**LOTS 4, 5 & 301 (5) WARTON STREET, COTTESLOE
PROPOSED EIGHT MULTIPLE DWELLINGS
SUBMISSION OF REVISED PLANS**

Planning Solutions acts on behalf of Cottesloe Investments WA Pty Ltd, the proponent of the proposed development at Lots 4, 5 and 301 (5) Warton Street (**subject site**).

**ATTACHMENT 1
REVISED DEVELOPMENT PLANS**

**ATTACHMENT 2
VIEW ANALYSIS**

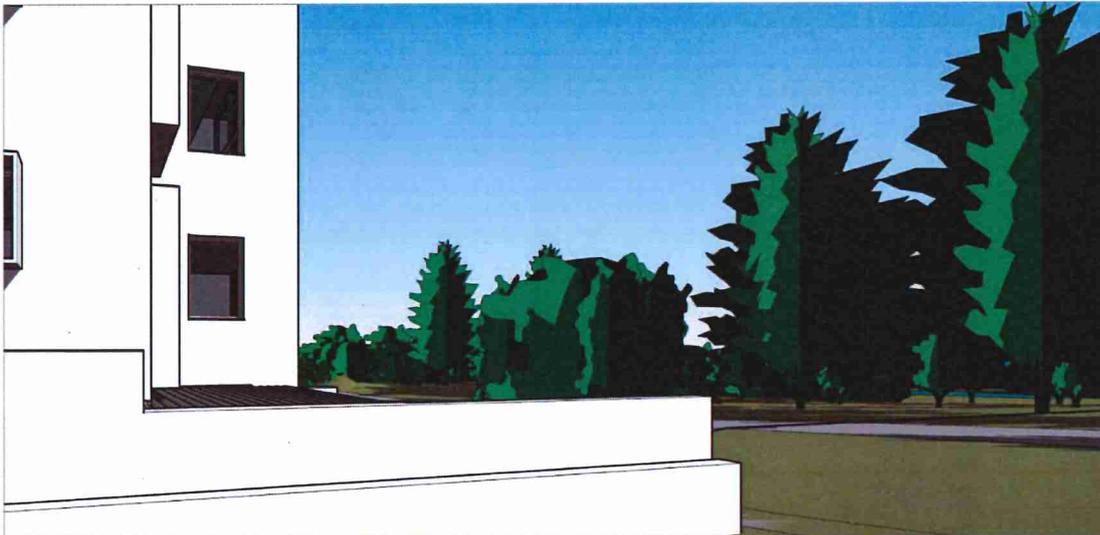
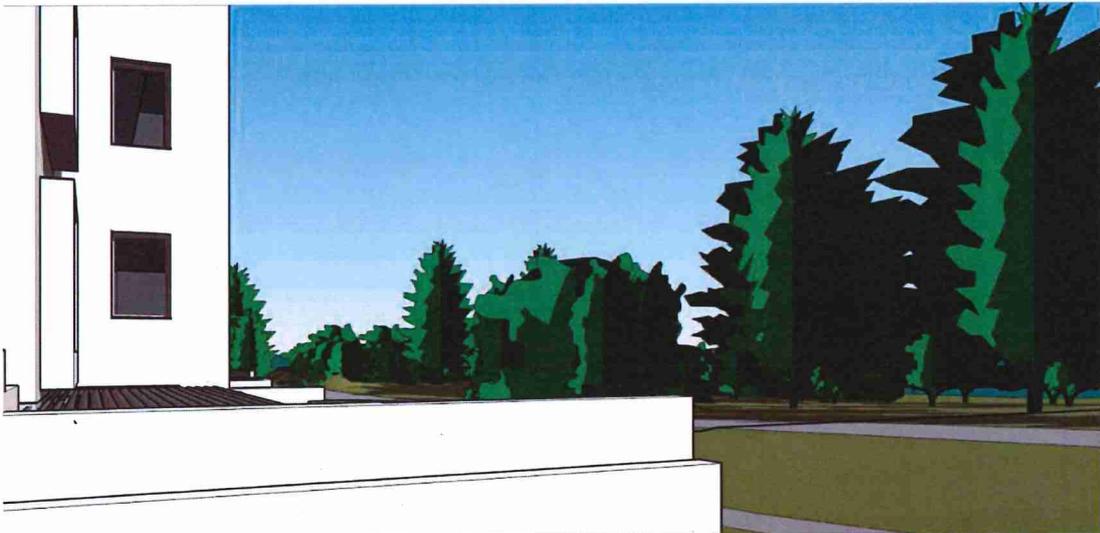
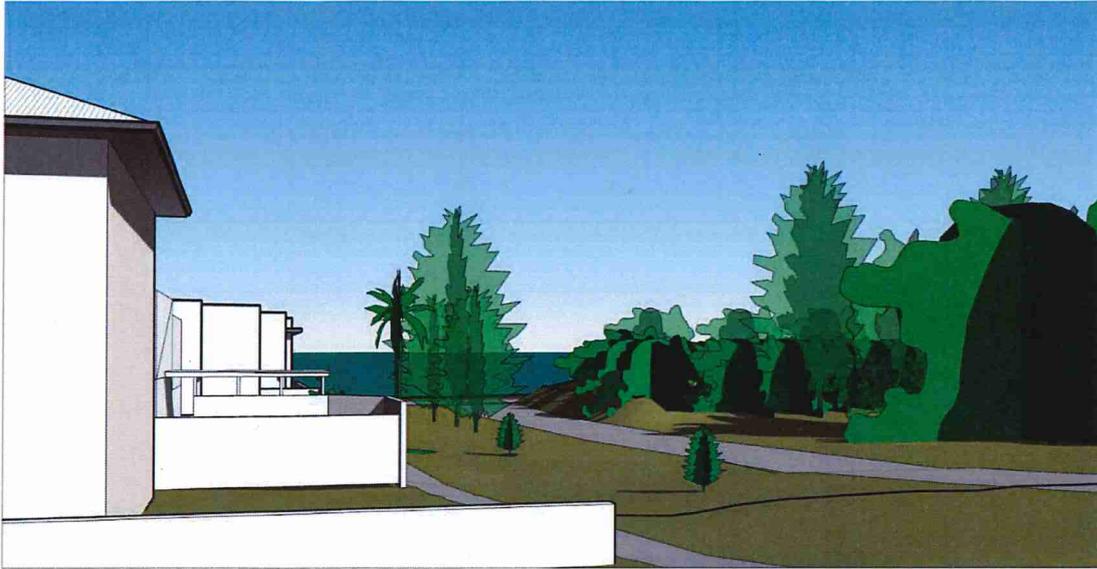
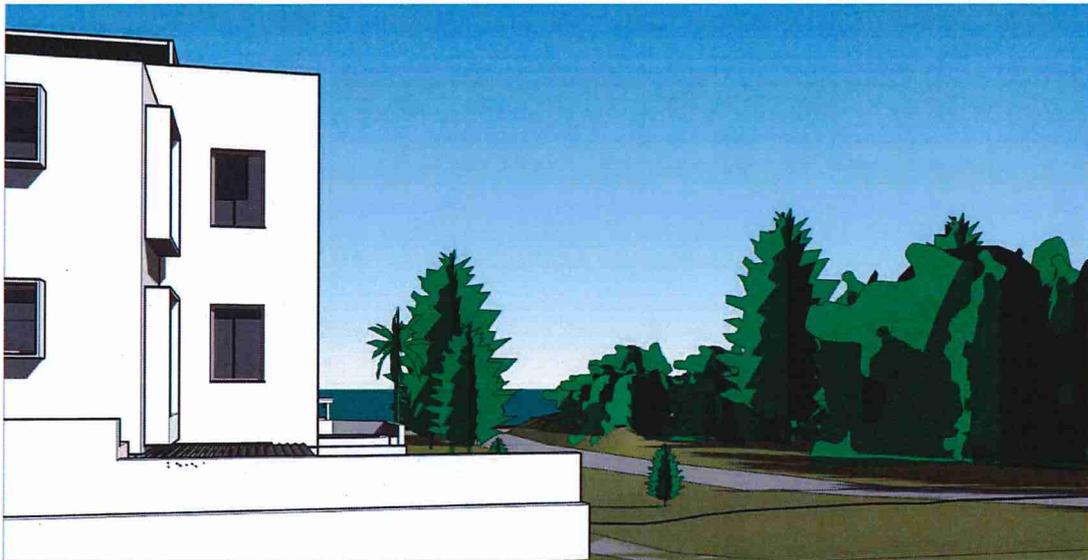
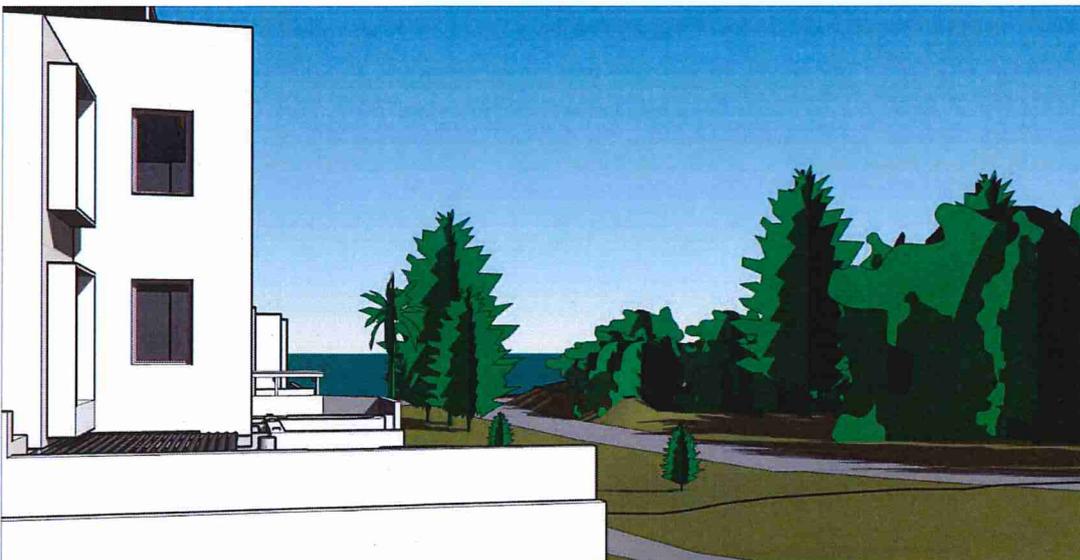
A revised view analysis is provided in **Attachment 2**. The view analysis compares the existing views with the previous plans and the current plans. By increasing the street setback from 4m to 5m, the view toward the ocean broadens by 7 degrees. The analysis in Attachment 2 shows this visually, demonstrating a generous increase in the views which are afforded to the front balcony and courtyard of No. 7 and No. 9 Warton Street, Cottesloe respectively.
